Response to Worcester LCWIP

Network consultation

October 2025

Network consultation - Bike Worcester

Route A (Primary) - Hallow to St John's and Dines Green

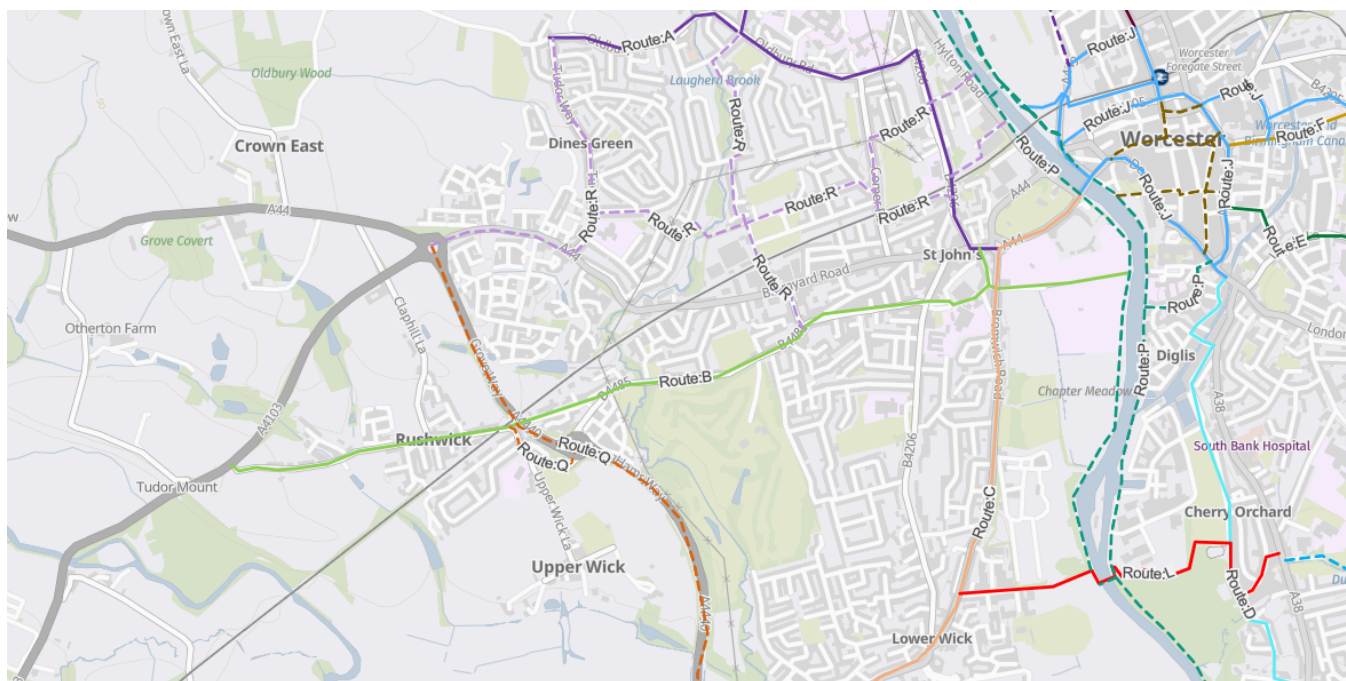
We agree this is needed as a primary route. We would expect a good quality route would be well used by the community. The proposed route is not sufficiently direct and could be extended directly to Henwick and Hylton Road.

Rob C	The proposed route is not sufficiently direct: it would take large amounts of signage/guidance to divert cycles off Hallow Road onto Monarch Drive instead of taking the direct route into town. Currently, multiple Bike Bus run on these routes to Oldbury Park Primary School
Dan B	Would use. Agree with Rob C comment. There is plenty of scope to extend this straight down Hallow / Henwick / Hylton Road. And why stop at Hallow? A route crossing the river at Bevere would link both Grimley and Hallow via existing cycle route, to existing routes (NCN?) through Northwick and Barbourne.
Wilf	Not direct and involves a tricky southern link across Bull Ring. The route should provide a more direct link along Hylton Road to Hallow Road. There needs to be a safe route through the Bull Ring to Hylton Road. Also easier movement into Henwick Road at both ends. The route along Comer Gardens is useful from Laugherne Brooke/Comer Road/Dines Green area, but is a significant diversion from the main route Comer Gdns is narrow with fast traffic, it needs cycle friendly infrastructure and calming.

Route B (Primary) - Rushwick to St John's and Riverside

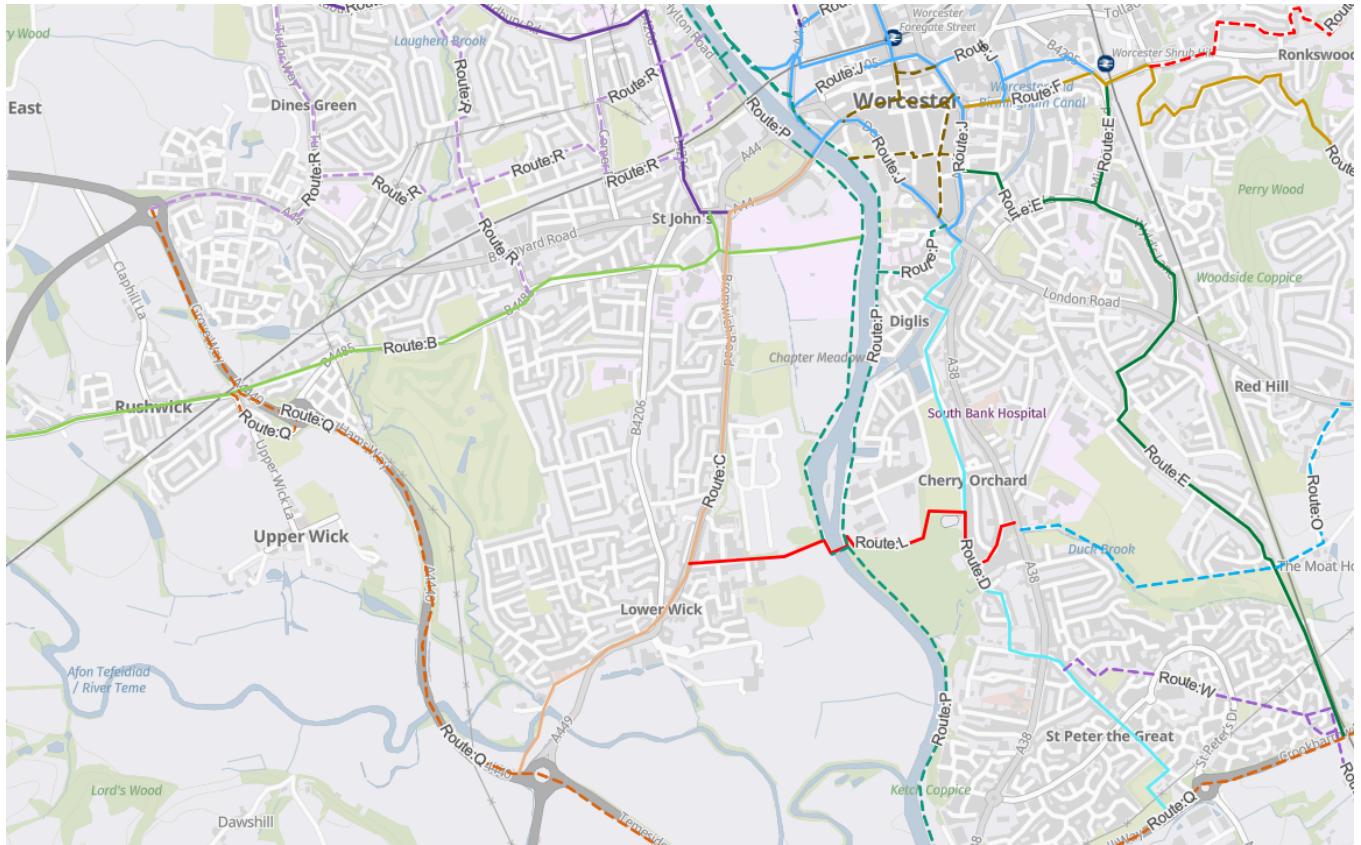
We agree this is needed as a primary route. We would expect a good quality route would be well used by the community.

Al P	The riverside route is too narrow to safely accommodate both pedestrians and cyclists. To be fit for its intended purpose, the surface would need to be substantially wider. Where the path joins Swanpool Walk, the width is again insufficient for shared use. Furthermore, the bollards after the crossing are too close together to permit access for cargo bikes and assisted cycles. The suggested route along Bransford Road is not a safe solution, as local residents have highlighted this as a speeding hotspot. To make this a viable option, effective speed reduction measures would be essential.
James N	Bromwich Lane is one way, so going towards the City Centre is fine. But when you are coming back, you either have to join Bromwich Road and cycle on the busy roundabout or cycle on the thin pavement with multiple obstacles (it is unclear whether this section is shared use, the pedestrian crossing lights suggest some shared use). You can then join Bromwich Lane next to where the Mobility Showroom is.

Dan B	Good route, would use if continuous, but also likely to connect Sabrina via existing decent routes (shown as secondary?)
Wilf	Good route. However it needs 2-way cycling on Bromwich Lane; needs a cycle-friendly crossing point between Bromwich Lane and Swanpool Walk; Swanpool Walk needs surface making good. Also needs decent, safe links onto and across the Bull Ring.

Route C (Primary) - Powick Roundabout to Worcester Bridge

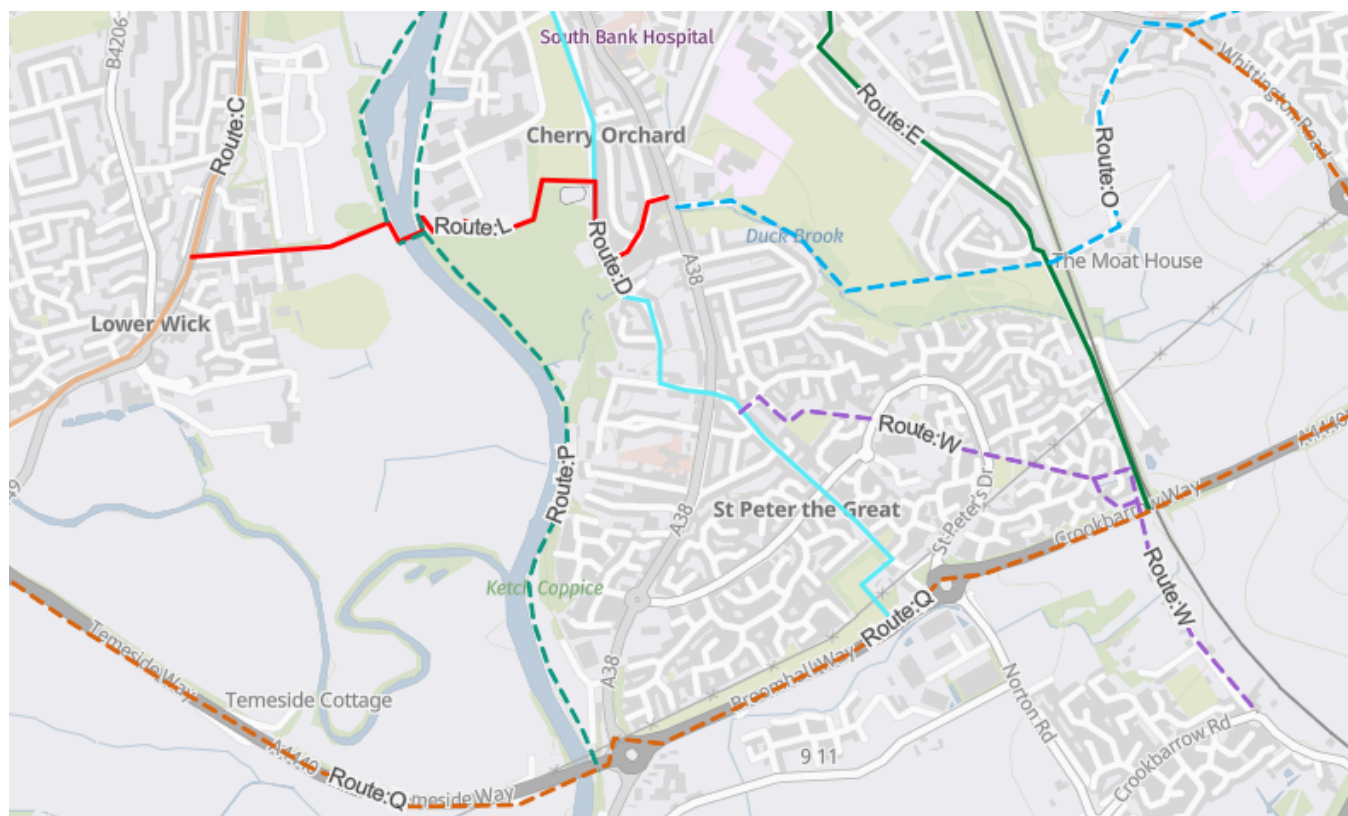
We agree this is needed as a primary route. We would expect a good quality route would be well used by the community. It would provide year-round infrastructure for all users, including women and girls (the river path is not user friendly for women in the winter). The route is terminated too soon as it doesn't connect to the city centre.

James N	I use this route multiple times a week. At rush hour, the roundabout outside the BP petrol station becomes very busy. Many cars do not stop to allow you to cross. If you are coming from Regina Close, the limited visibility caused by the curve of the road and the hedge combined with the speed of the traffic (at times) makes it feel intimidating to cross. I think I have also witnessed speeding down the B4206. Most of the lights on Hams Way Bridge are out at this point. I cycle on it late at night sometimes, but I feel like some people would be put off by this.
Dan B	Good route, would use. Pinch points on New Road / Bromwich Road junction would need work to provide continuous route.
Wilf	Better all-day route than the riverside - passive surveillance and lighting. New Road to bridge needs clarity; suffers from shared pedestrian/cycle arrangement and the short stretch of cycle-path on the south side which is cluttered with street furniture; not to mention potential conflict when crowds queueing for or exiting cricket ground. There seems to be no reason why the current three-lane circular road around Cripplegate Park could not be reduced to 2-lanes, with the third becoming a cycle-lane (similarly the bridge could lose a vehicle lane to cycling).

Route D (Primary) - Power Park to Sidbury

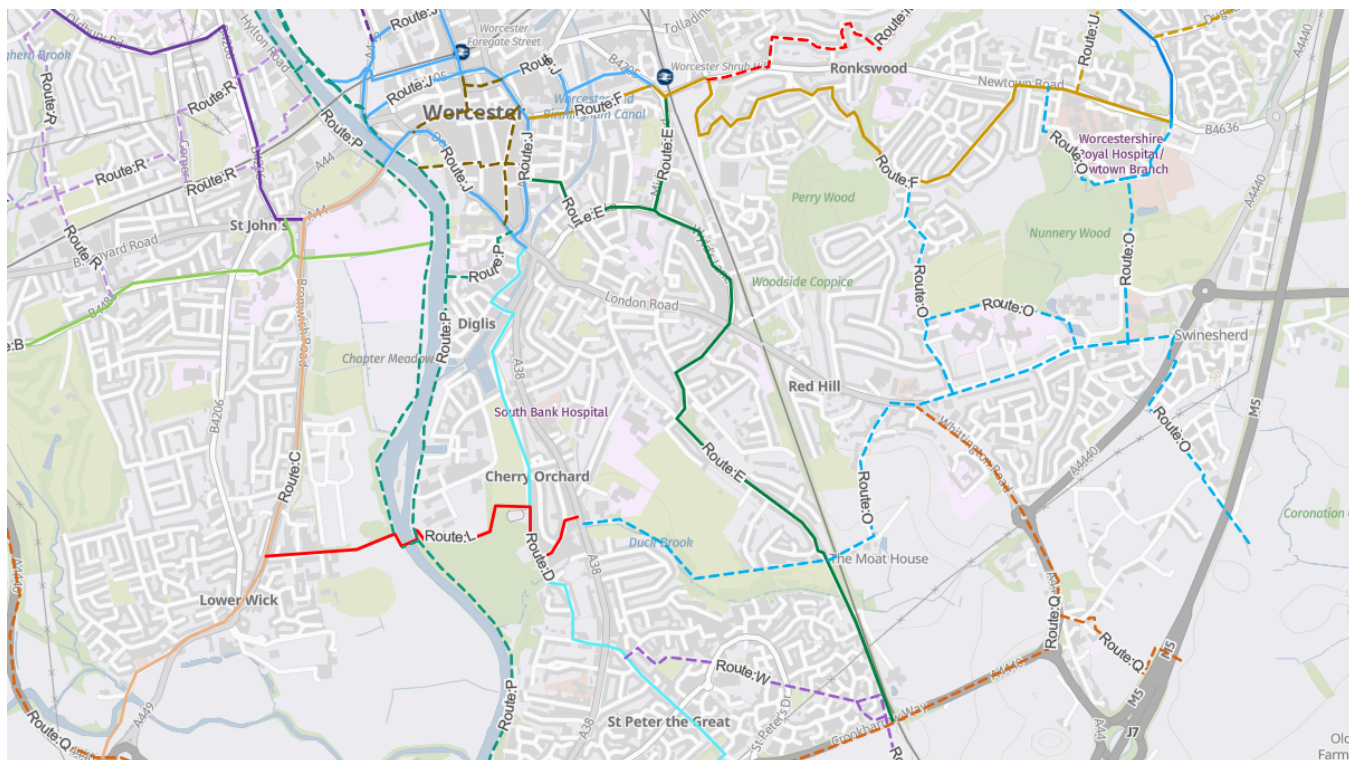
We think this is a positive suggestion as much of the required infrastructure is already in place, however we do not think it is a primary route. Whilst improvements could be made, we do not believe it should be a priority.

Al P	The shared use route from St. Martin's Cl to Barneshall Ave has bollards that are too narrow for cargo bikes and assisted bikes. On some days the traffic lights near where Norton Road meets Bath Road take almost a minute to change (similar to lights further along Bath Road).
Dan B	Route already exists and I use it, needs some improvements, would mostly be improved by removing parked cars. New crossing at Bath Road has offered little improvement at notable cost (I don't use the crossing).

Route E (Primary) - Broomhall Bridge to City Walls Road and Shrub Hill

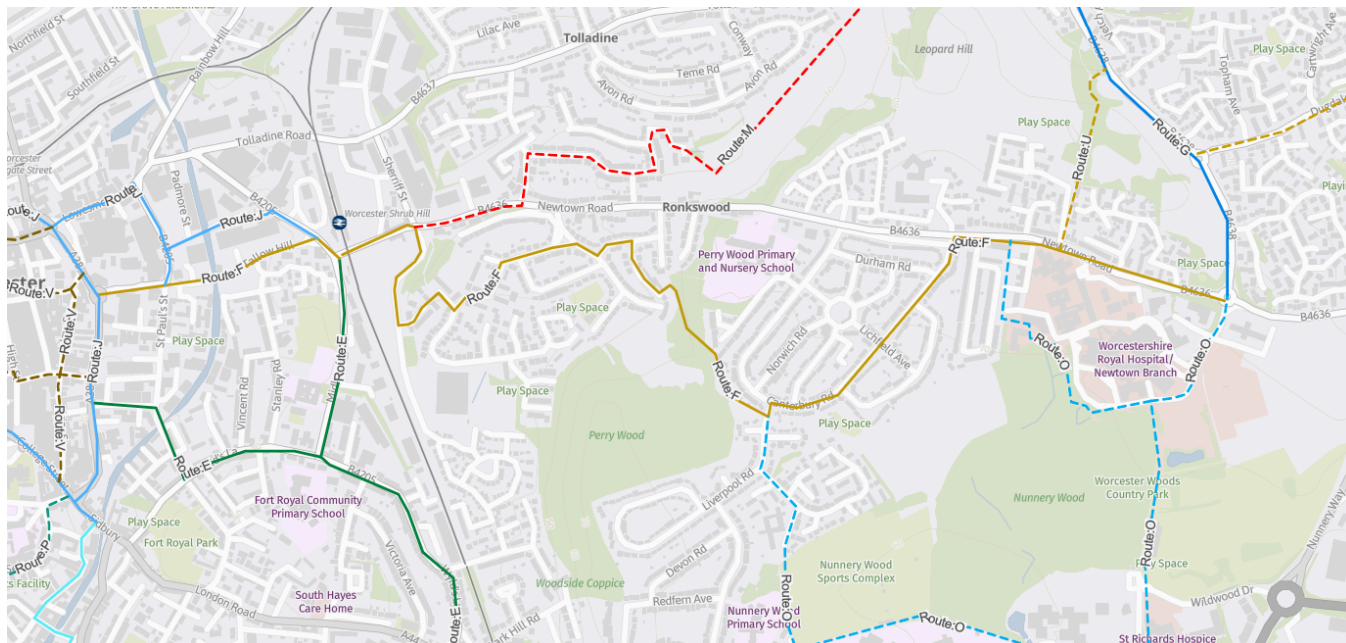
We agree this is needed as a primary route. We would expect a good quality route would be well used by the community. It would provide important connectivity to routes that are currently difficult to navigate.

Chantal	The route along Wylds Lane has the benefit of avoiding London Road which is very steep and on a bus route. However Wylds Lane between Midland road and London road is used by HGVs, some deliveries to sites on Wylds lane but some just using it as a short cut. There are lots of parked cars on this road as well. Is it intended to limit HGV access to this road? Will on road parking be no longer permitted? As if a cycle lane is marked on the road but not segregated it will likely be used for parking.
Chantal	This route appears to cross London road directly opposite Wylds lane, using Sebright avenue. This is currently a one way street. Is it the intention to allow cyclists to travel in both directions and remove some on street parking to make this possible? If so, I would welcome this as it is currently necessary to use London road and camp hill road to get into Battenhall.
Dan B	Good route, would use. Making Sebright bidirectional provides a really good link crossing London Road. There are other opportunities for this in the city that would greatly improve a network. I suspect the most important

feature on Wylds Lane would be removing parked cars.
Fleur	Wylds lane is currently not a safe/pleasant route to take as cars try to over take while there is only one lane available due to parked cars. Particularly the section by Perry Wood walk, I have witnessed some very dangerous situations. The west end of this route abruptly ends on City Walls road, which is a very unpleasant road to cycle along especially in north-south direction (other direction is much easier).

Route F (Primary) - Worcestershire Royal Hospital to City Walls Road

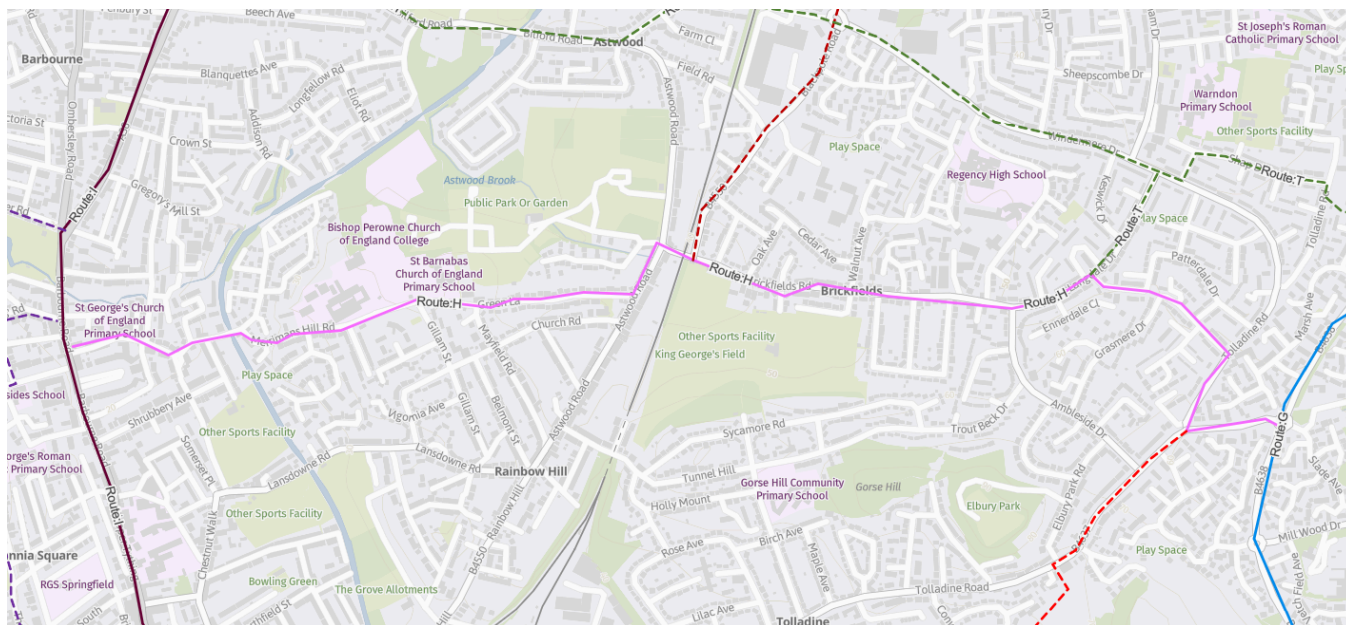
We agree this is needed as a primary route. The proposed route is not sufficiently direct. We would expect a more direct route to be well used by the community.

Dan B	I would NOT use this route as it is not direct. It should be a direct route from the hospital to Shrub Hill, in addition to direct routes to any other network nodes.
Fleur	This route is an important connection for people from Nunnery and Ronkswood area to go into town without having to take a massive detour. The main pinch point for travel in this direction, is the Newtown Road tunnel and the Midland Road crossing after the tunnel, which are extremely scary to undertake for any cyclist, particularly having to go into the tunnel (which is even a very random experience for car drivers). If the current situation remains there will be no increase in usage on this route. Currently it is also very dangerous for pedestrians to cross Williamson Rd when coming from te Newtown tunnel. (comments continue in next box) With a bike turning from the tunnel into Williamson Rd. is currently also very tricky. I tend to cross Sherif street and then use the pedestrian crossing on the other side of the road, as it is (especially with child) very scary to wait in the road for an opportunity to cross Newtown rd. Personally I do not bother going up Williamson road, but take the steps leading to Ronkswood Crst. The section through Perry Wood reserve from Dart Rd. towards Canterbury Rd. is currently not suitable for cycling, as it is too narrow to allow passing of pedestrians (especially those with dogs, who often do not bother get out of the way). Joining City Walls Rd, from St. Georges St. at the west end of this route also is not easy to do for a cyclist. This roundabout is not suitable for anyone other than an experienced cyclist. The cycle lane up to the roundabout by St. Pauls street suddenly ends and leaves you in a limbo before you can get onto the roundabout.

Route H (Primary) - Warndon to Barbourne

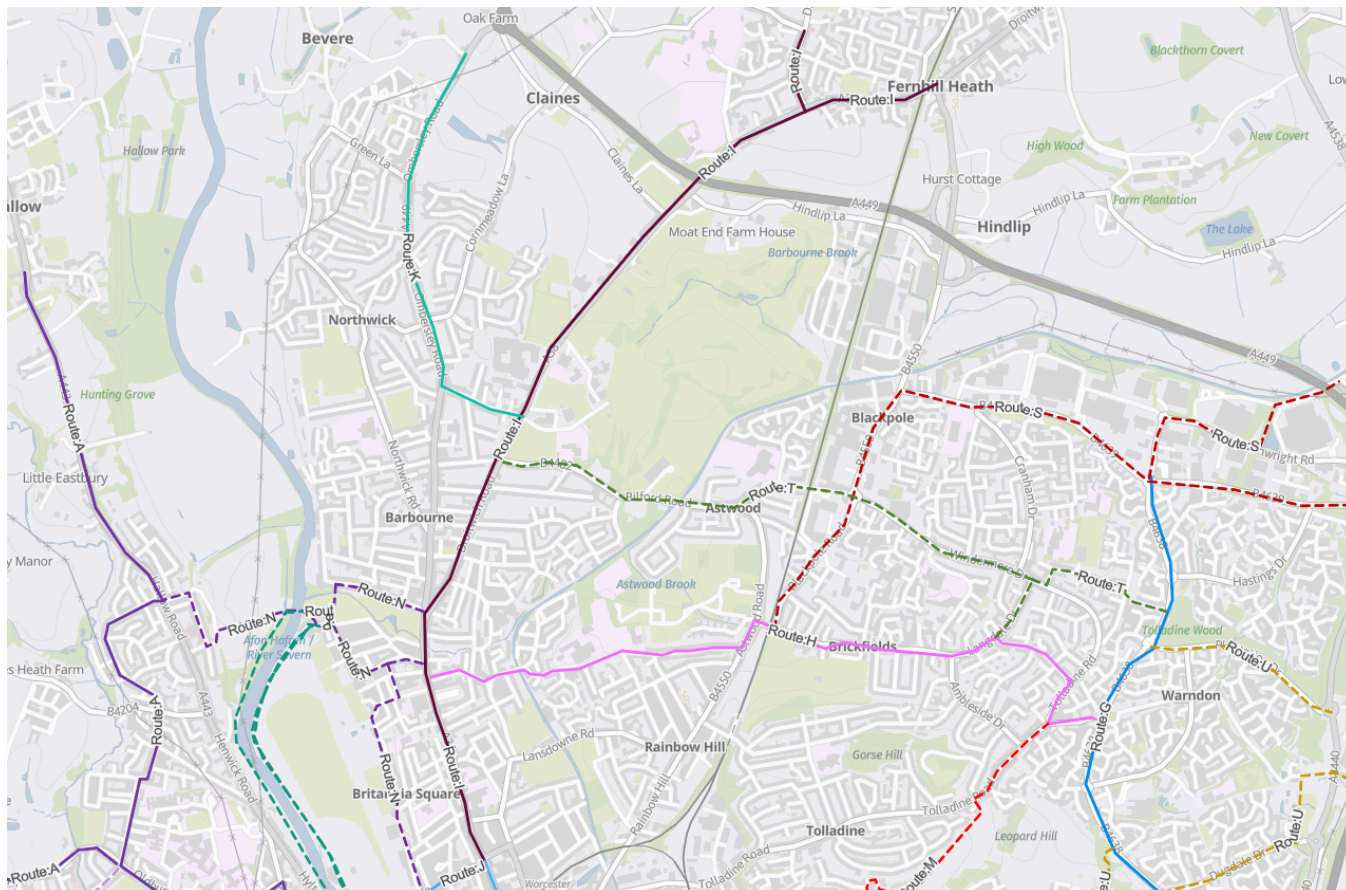
We agree this is needed as a primary route. We would expect a good quality route would be well used by the community.

Dan B	Not a route I currently use, but I'm not sure why as it's pretty direct for some journeys I regularly make, so I guess I would use it if it was direct.
-------	---
